West Parcel Solar Project

Project Final Tiered EIR

***Volume 4
Response to Public Comments on the Draft EIR
Appendices***

UWT Response to the July 2017 NOC of Tiered Draft EIR for the Mt. SAC West Parcel Solar Project

Hillside Losses from Solar Project Traveling form Snow Creek Drive to Amar Road

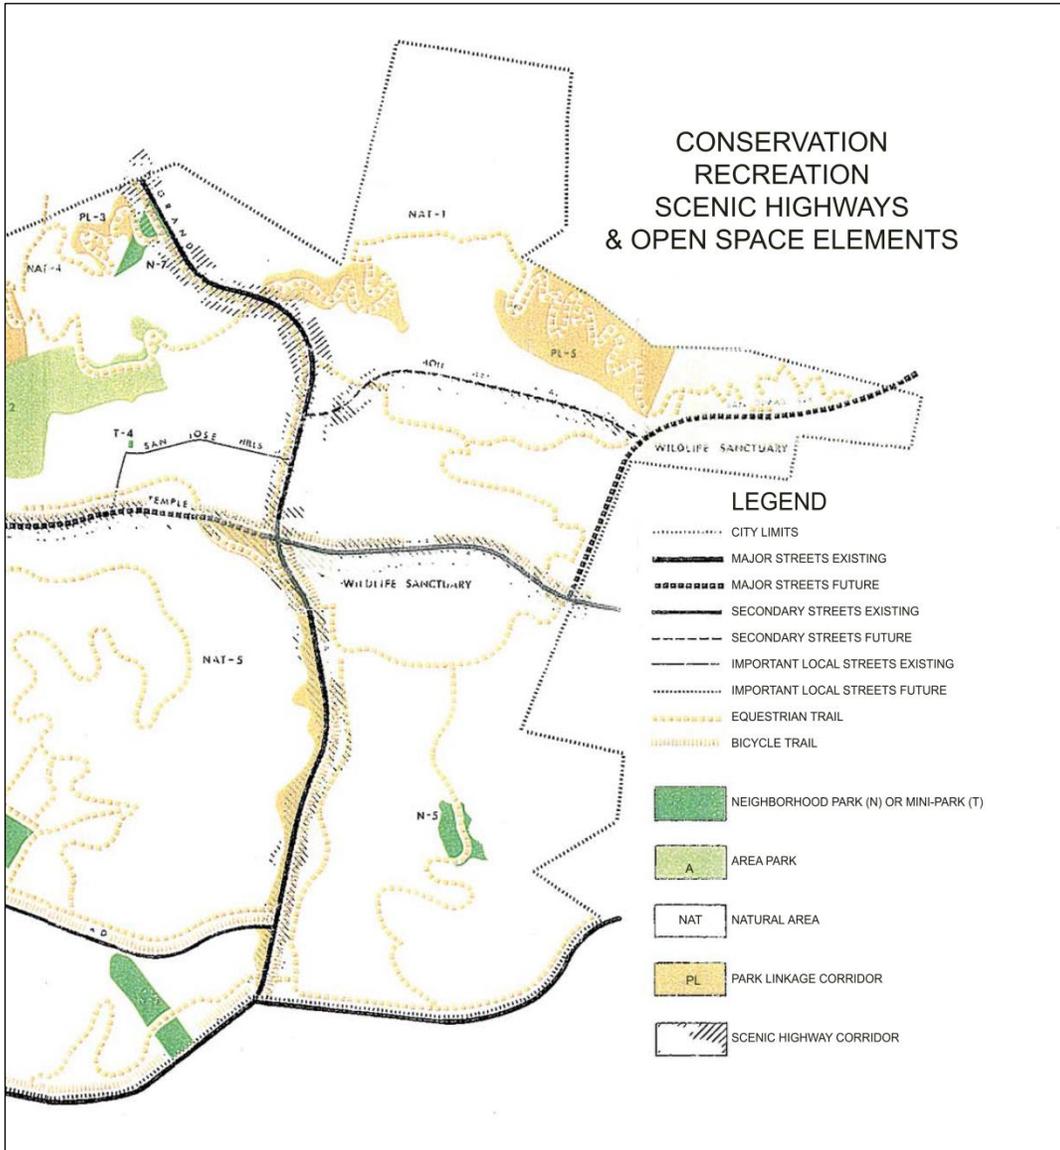
5. Motorists traveling Grand Avenue would observe loss of hillsides, which is inconsistent with the General Plan Scenic Corridor designation of the roadway. The following views of Grand Avenue (photos 1 through 3, below) traveling from south to north from Snow Creek Drive to Amar Road displays the scenic values of Grand Avenue at street level and the significant destruction of native hillsides and vegetation caused by the west parcel project.

Figure 1

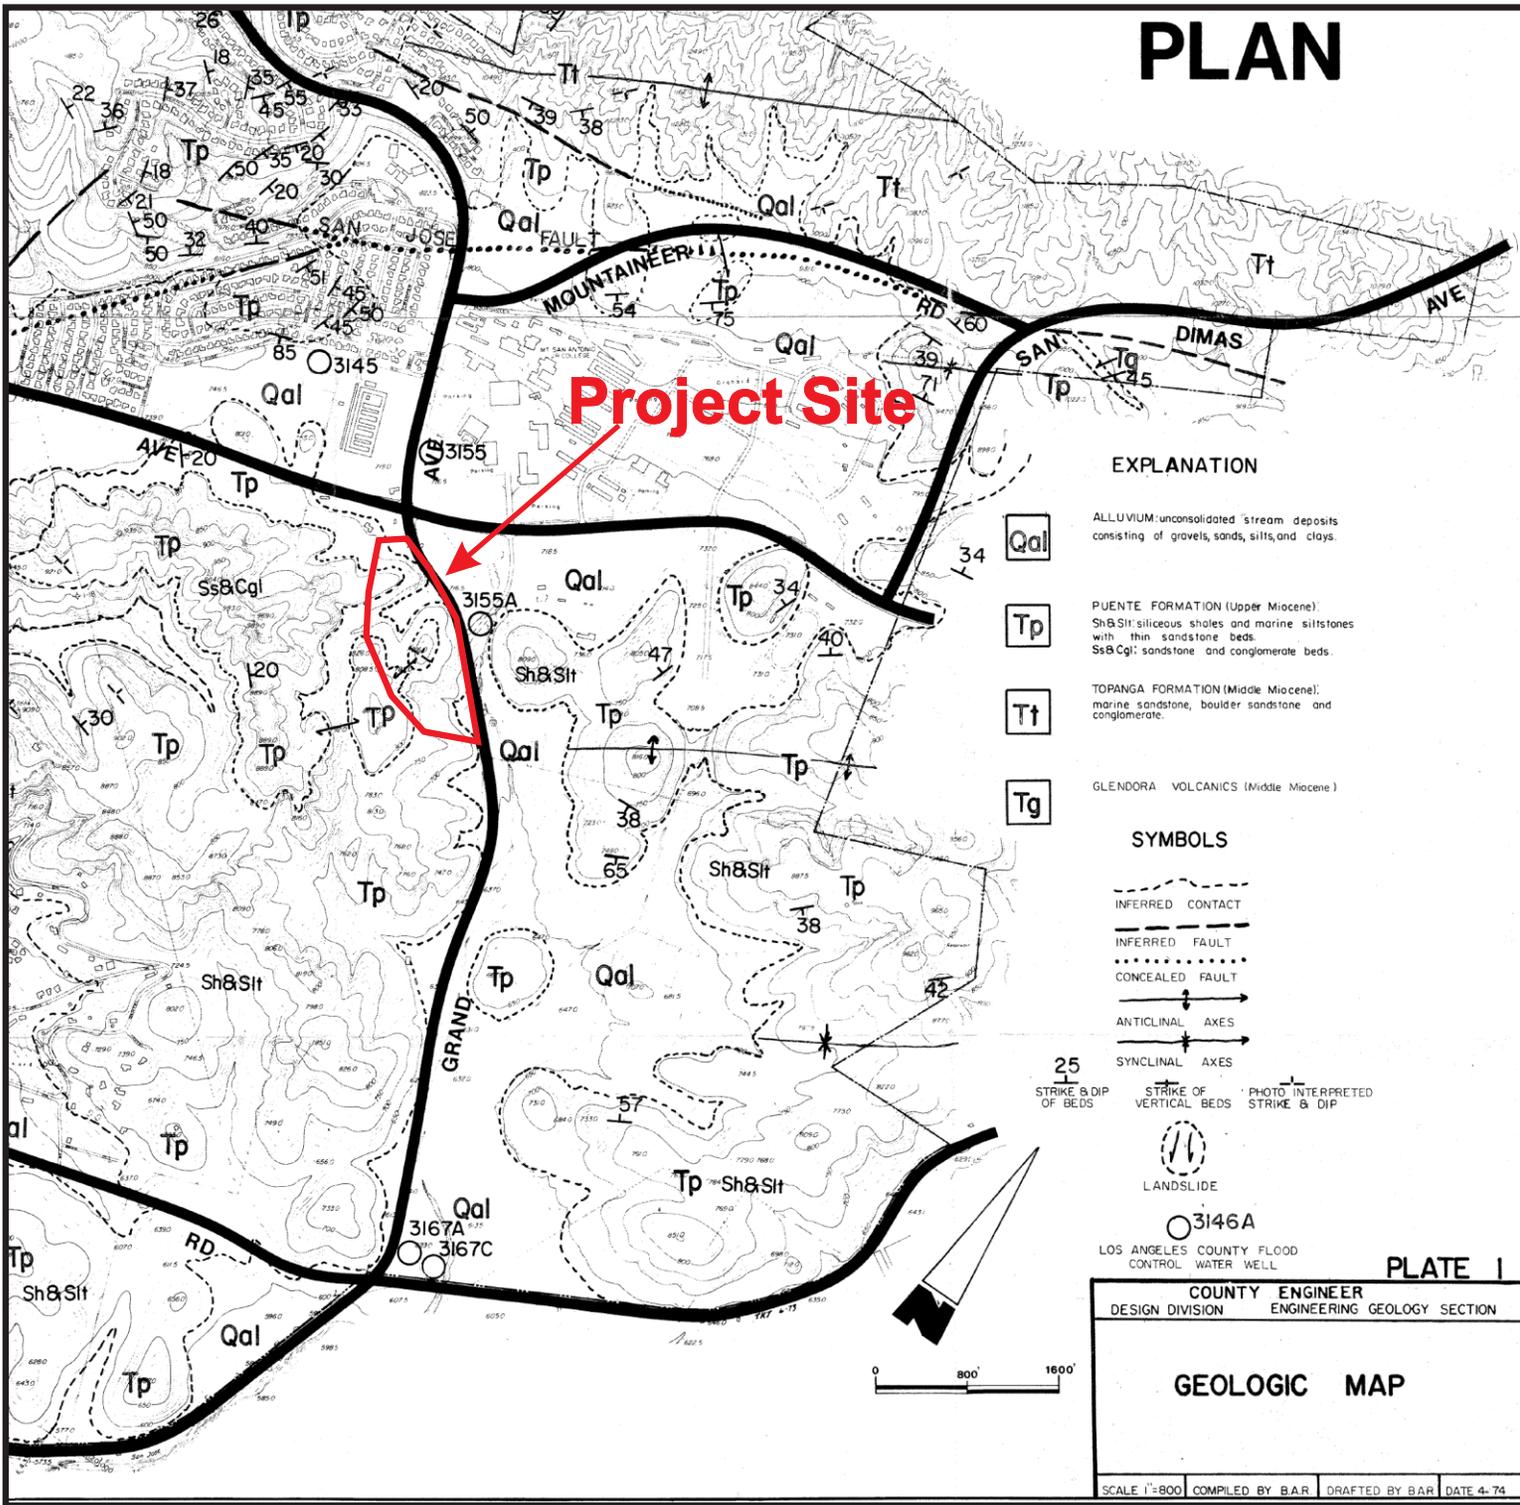
The grading plan prepared by Psomas includes cut and fill grading to create a large pad area at an elevation ranging from 758 to 763 feet in elevation. To accomplish this, the pad area will require cutting down of the central hill, approximately 55 feet, and filling in the two valley areas up to approximately 60 feet. A large slope is proposed along Grand Avenue, which includes filling and cutting and is up to 80 feet in height. Two cut slopes are proposed along the northwestern perimeter of the site that are up to 40 feet in height. A fill slope up to 25 feet in height is also proposed along this edge. According to the grading plan approximately 139,000 cubic yards of import fill materials will be necessary to balance the cut/fill volumes proposed on the plan. The plan does not provide an estimate of remedial quantities to remove unsuitable earth materials and/or the corresponding shrinkage/bulking factors that are typically required by reviewing agencies.

Figure 2a

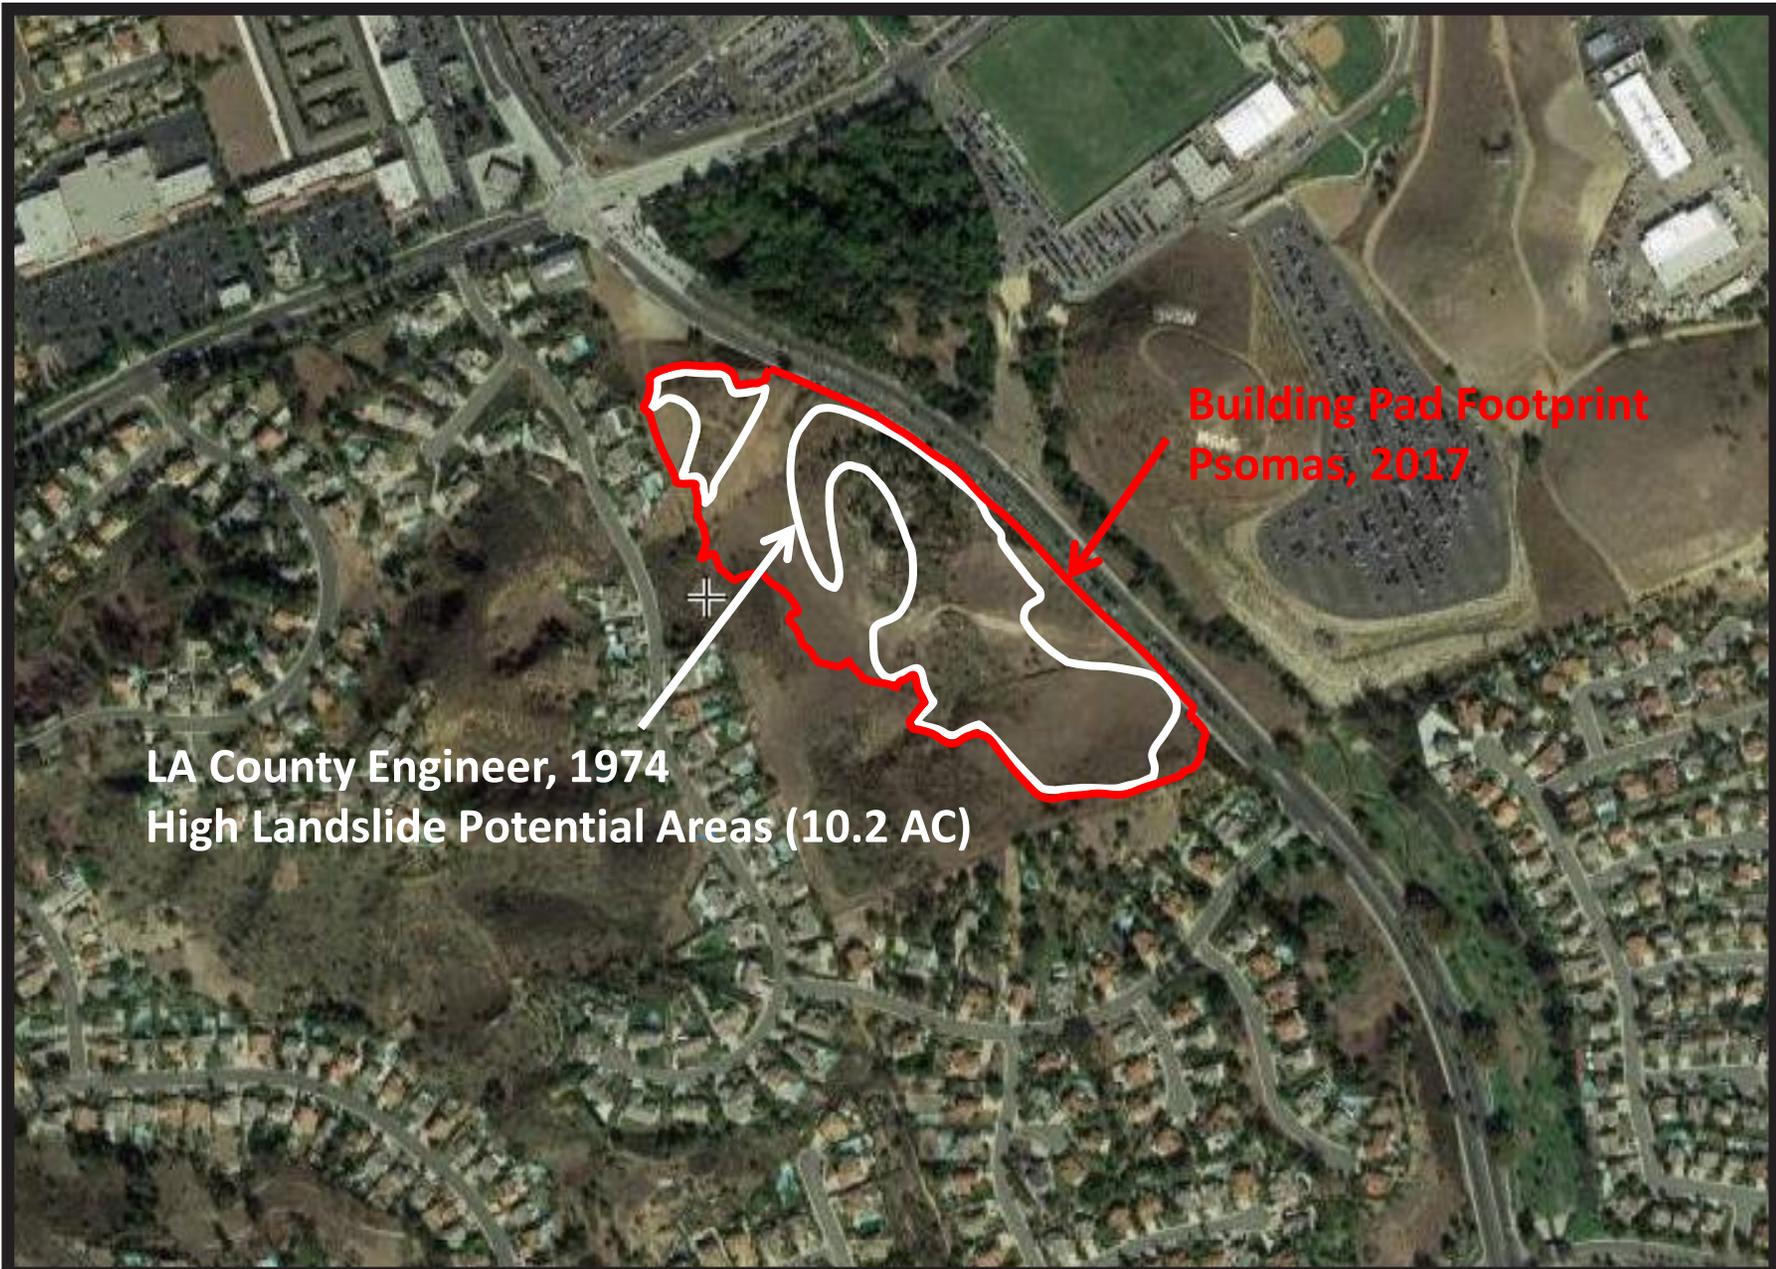
The Dibblee map (1989) was presented by Converse in their report and indicates the site is underlain by bedrock of the Tertiary Sycamore Canyon Formation which is the uppermost member of the Puente Formation, and that bedding is generally striking northwest-southeast and dipping 15 to 30 degrees to the northeast. The surrounding areas are indicated as being underlain by the Tertiary Yorba member of the Monterey (Puente Formation) with similar bedding orientations. According to the Geologic Map (City of Walnut, 1974), the site is underlain by bedrock of the Puente Formation. This map (Figure 1) indicates that the central knob and adjacent hilltops are underlain by sandstone

and conglomerate, however, the lower portions of the hills are shown as underlain by shales and siltstones. TSI's brief observations at the site indicate sandstone and conglomerates are present as well as shales and siltstone in the central knob area. Where the shale and siltstone was observed, bedding was dipping to the east-northeast approximately 20 to 30 degrees (similar to as indicated by Dibblee [1989]).

Figure 3b

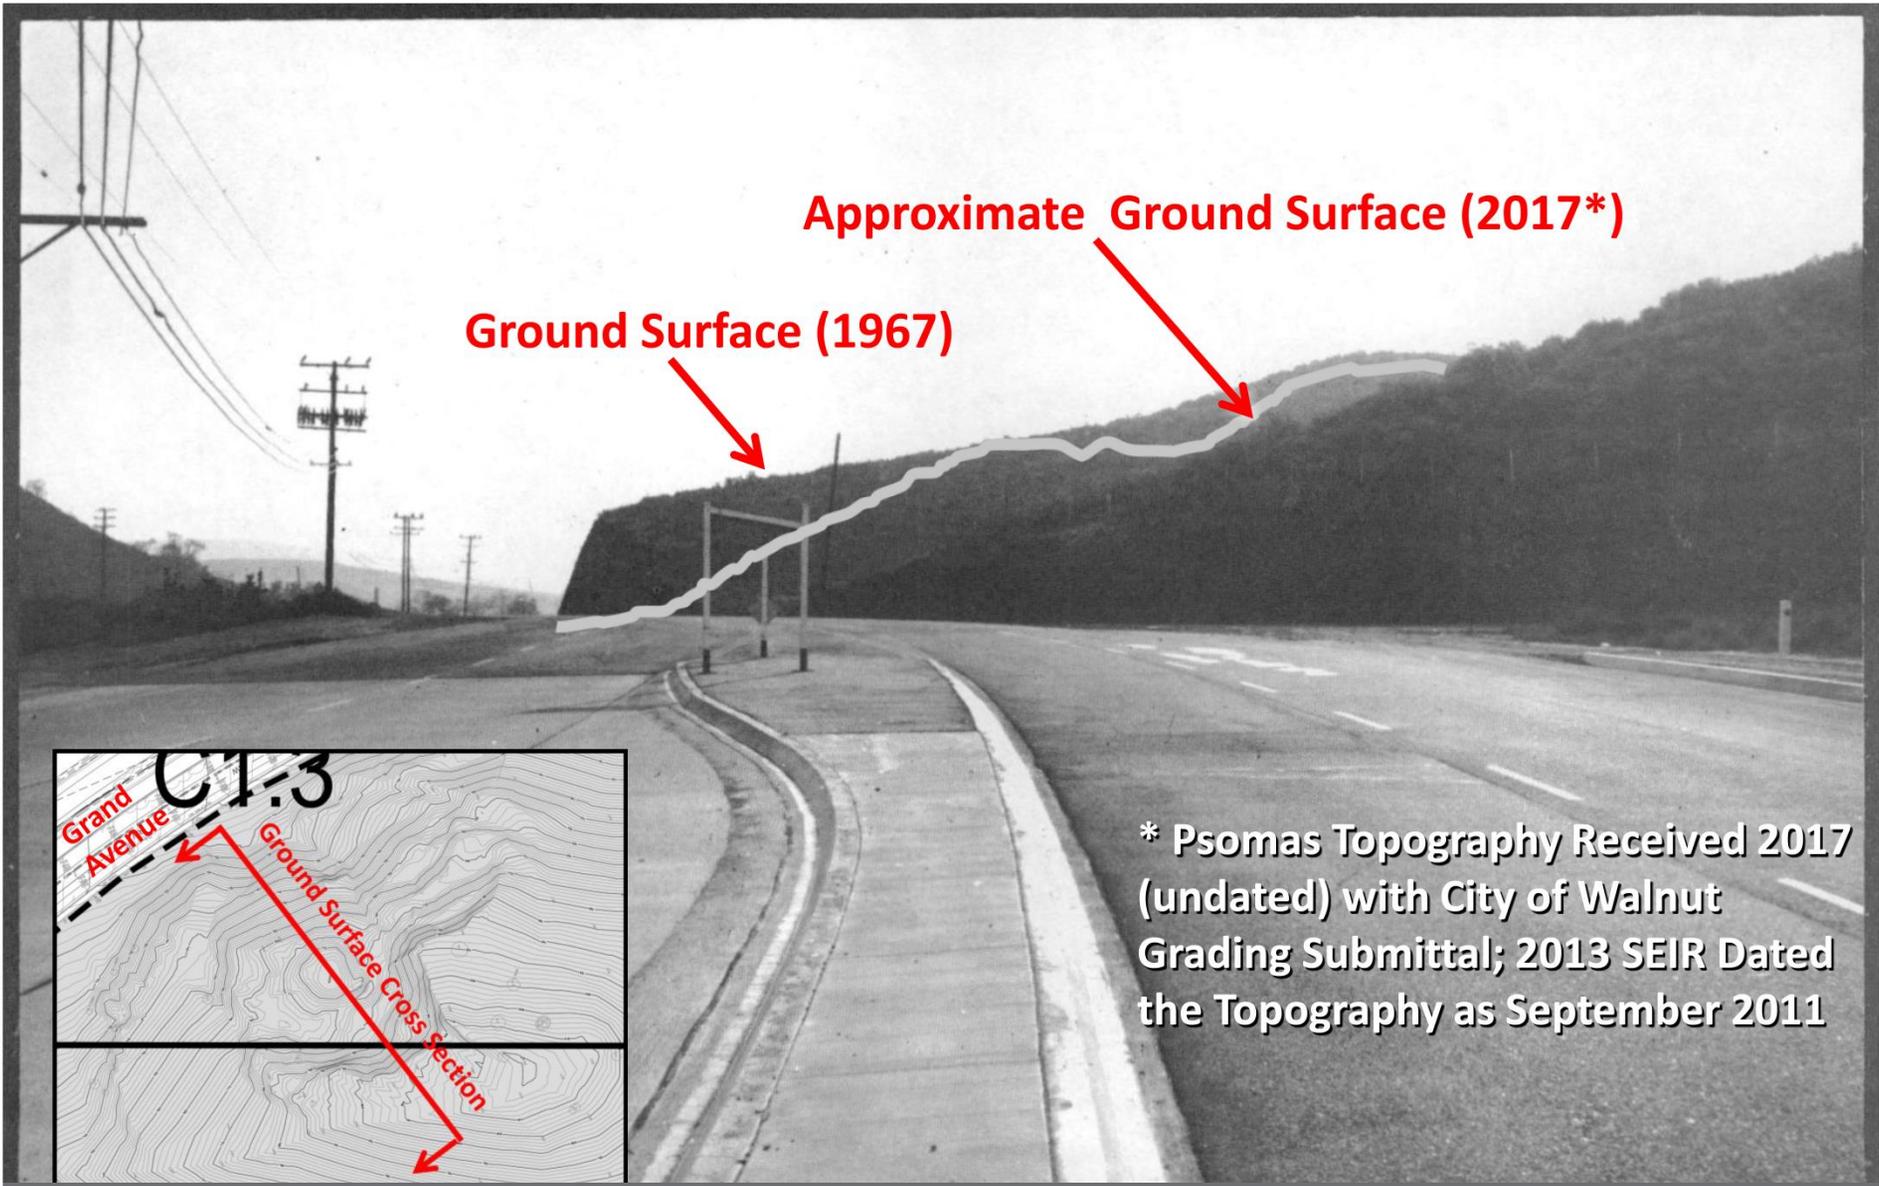
that underlie them can be expected to fail, locally when modified by natural processes or the activities by man because they are close to their stability limits.”

These figures clearly indicate that the proposed project is within areas that were previously determined by governing agencies to have a significant potential for slope instability and landsliding.

Figure 1

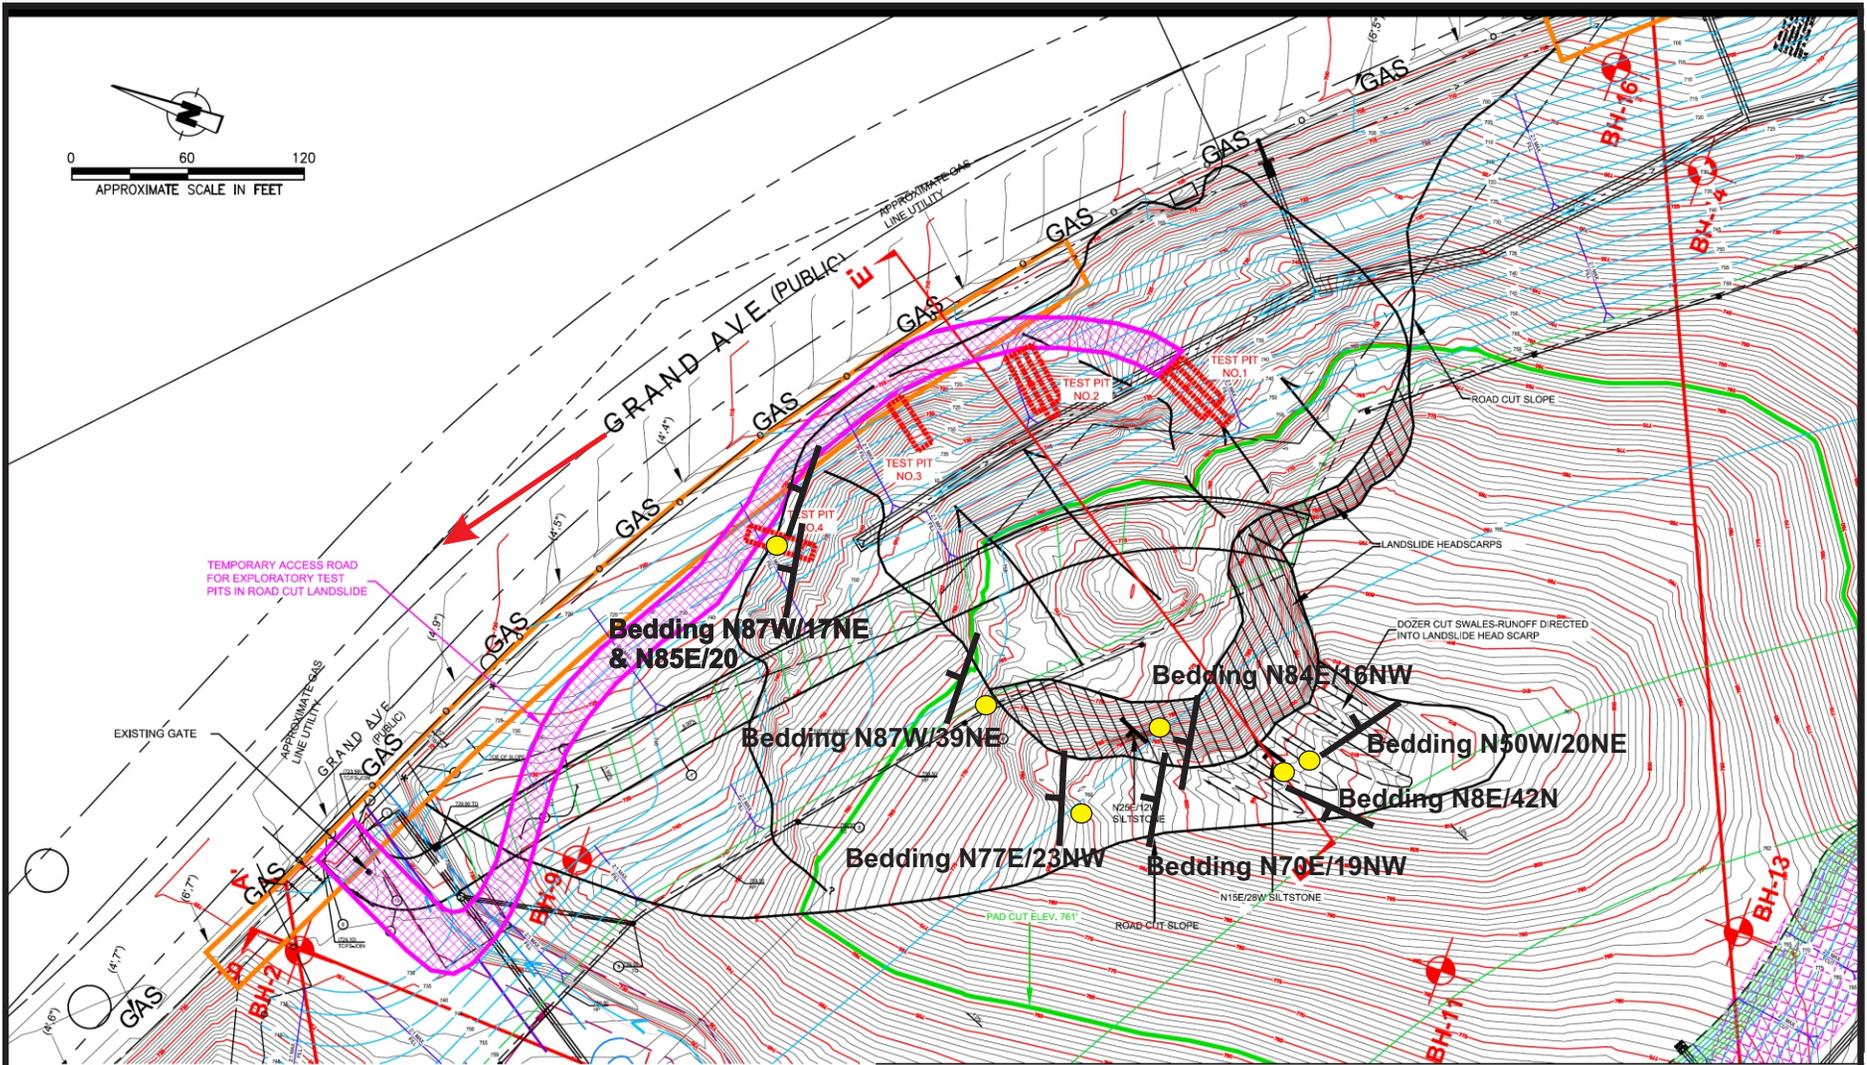
The Converse report identifies a landslide in all four of the test pits excavated, and Drawing No. 1 has several lines possibly indicating the limits of the landslide or several landslides. The limits of the landsliding is unclear because not all lines are labeled and no legend is provided for Drawing No. 1. Four arrows are shown that likely indicate the direction of landsliding (one or two landslides) however, in the area of Test Pit No. 4 there are no arrows and the line which may show the limits of landsliding is discontinuous to the west and ends with a question mark. An area that is indicated as landslide headscarp is indicated on Drawing No. 1. There is no discussion in the text of the report regarding multiple landslides, multiple pieces of the same landslide, or the limits of landsliding.

All four test pits indicate that a landslide slip plane was encountered and that the bottom portion of the test pit encountered bedrock. There were no slip plane attitudes indicated in the trench logs, or descriptions of the slip plane (except possibly Test Pit #3). Bedding attitudes were noted within the bedrock in all four of the trenches. The bedding attitudes were variable within the test pits. However, within Test Pits 2 through 4 most of the bedrock bedding attitudes had nearly east-west strikes with dips ranging from 12 to 21 degrees to the north. In Test Pit No. 1 the bedding attitudes had a strike ranging from north 52 to 65 degrees east and northwesterly dips ranging from 12 to 22 degrees. The two attitudes near the headscarp had strikes that ranged from north 15 to 25 degrees east with dips of 12 and 28 degrees.
